**Subject: TCB Services on a 35W Digital Mobile Transceiver (762-870 MHz)**

As per Elite Quotation EEE2202062-1 please carry out FCC (C2PC) PAG to the existing Grant / Certification for our Digital Mobile transceiver:

- FCC ID: CASTMBK5B

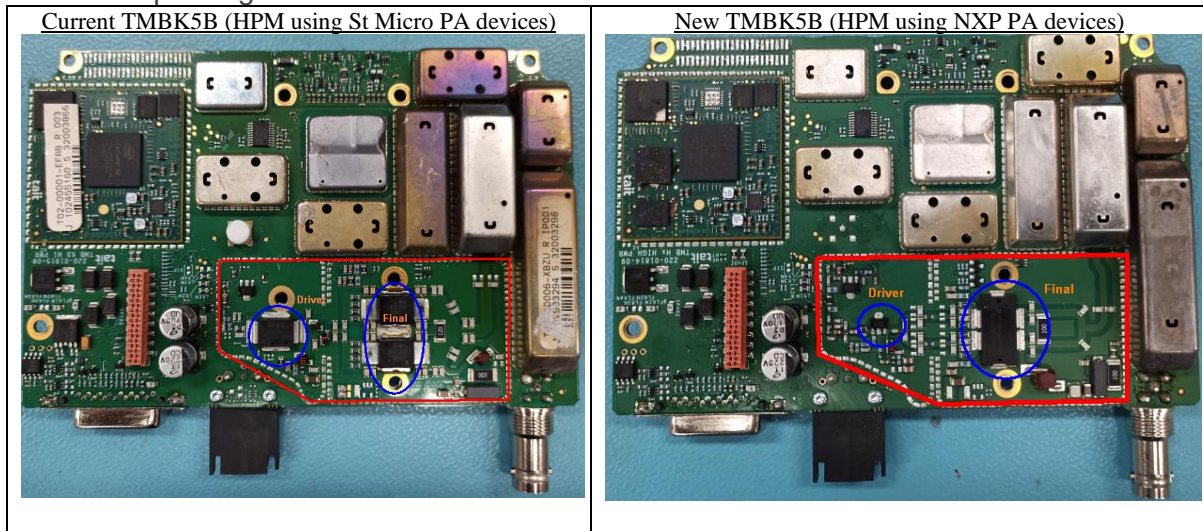
Due to supply chain issues and shortages, the following changes were necessary:

- The 6W (PD85006) driver PA will be replaced with 4W driver (AFT05MS004NT).
- The final PA 2x PD85035S will be replaced with a dual path (AFT09MS055GN).

The circuitry of the VCO, Synthesizer, Exciter, the Tx/Rx PIN and Low Pass Filter remain unchanged.

Tests were performed to verify and proof that no degradation on the RF performance of the equipment occurred due to these changes.

The pictures below have on the left the current granted hardware and on the right the one we are requesting for a C2PC PAG.
